# COUNTY COUNCIL'S RESPONSE TO CONSULTATION ON THE FOLLOWING DEVELOPMENT PROPOSAL

**Application No:** 20/00293/OUT

**Proposal:** Outline application (Phase 1B) including access (all other matters reserved) for approximately 4,413 sqm B1 office space (47,502 sqft) GIA, approximately 273 residential units (Use Class C3) including ancillary gym, approximately 177 sqm GIA of café space (Use Class A3), with an ancillary, mixed use co-working hub (794 sqm/ 8,550 sqft GIA), multi-storey car park, multi-use games area (MUGA), amenity space, associated infrastructure, parking and marketing boards

**Location:** Bicester Gateway Business Park, Wendlebury Road, Chesterton

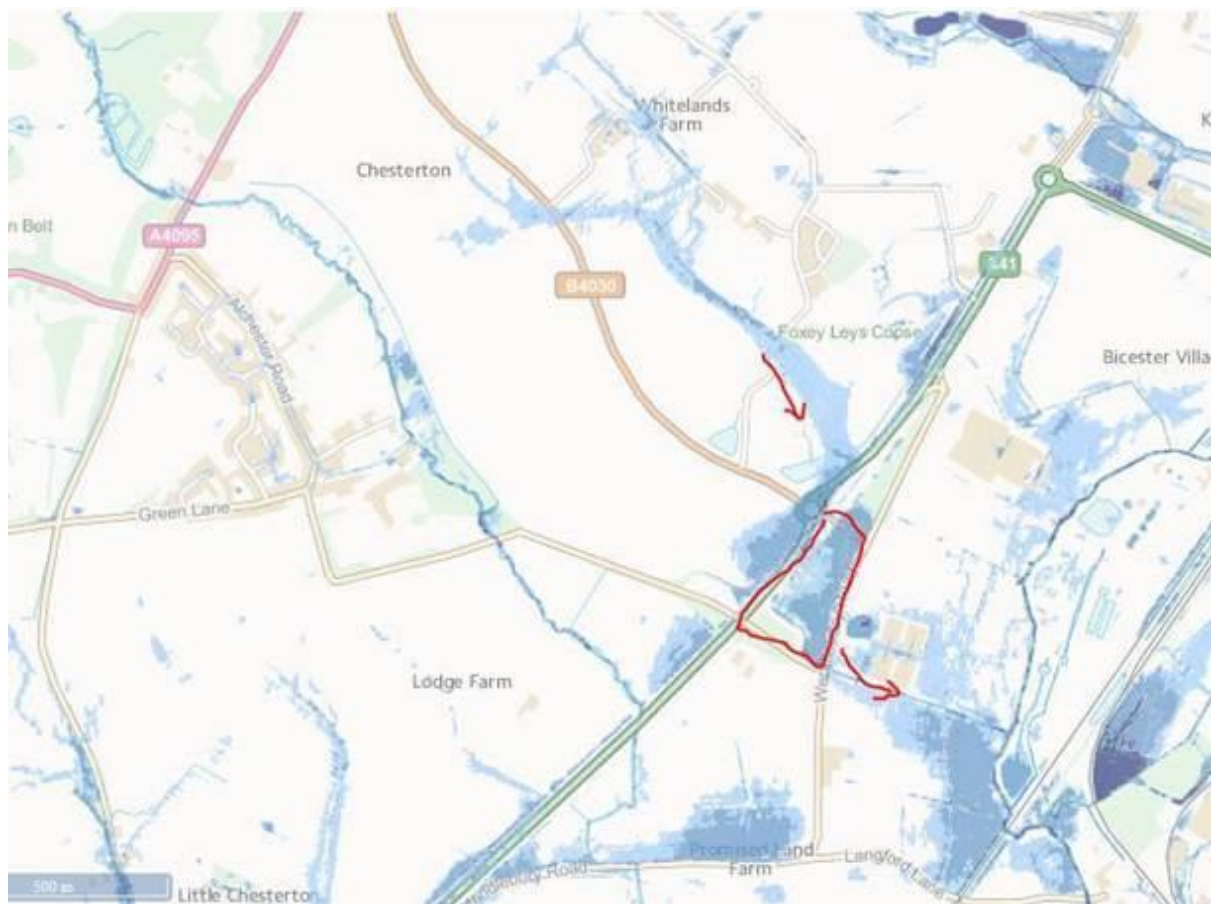
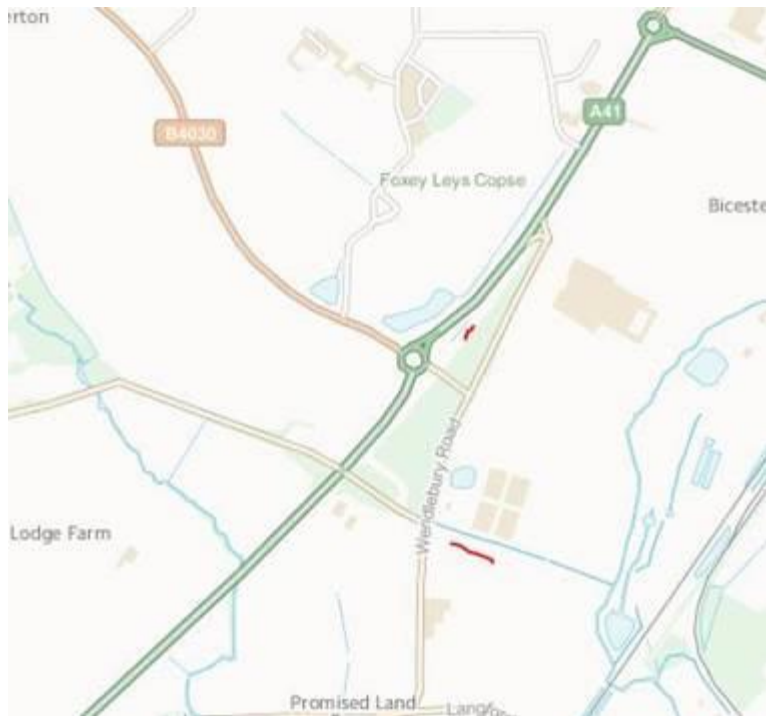
Paragraph 8.10.11 cannot be conditioned as it does not reflect what is shown on the drawings which demonstrate a tank to pump system.

Paragraph 8.9 shows not indication of the swale as described in the text.

Modelling of the watercourse flows in 1D and 2D should be undertaken to demonstrate there is no risk of flooding elsewhere in the catchment as per the guidance set out in NPPF. See the following:

The provided survey shows the ordinary watercourse. This discharges into culvert part way across the site. No mention of culverting of watercourse in FRA for which it will be necessary to seek permission for and easements.
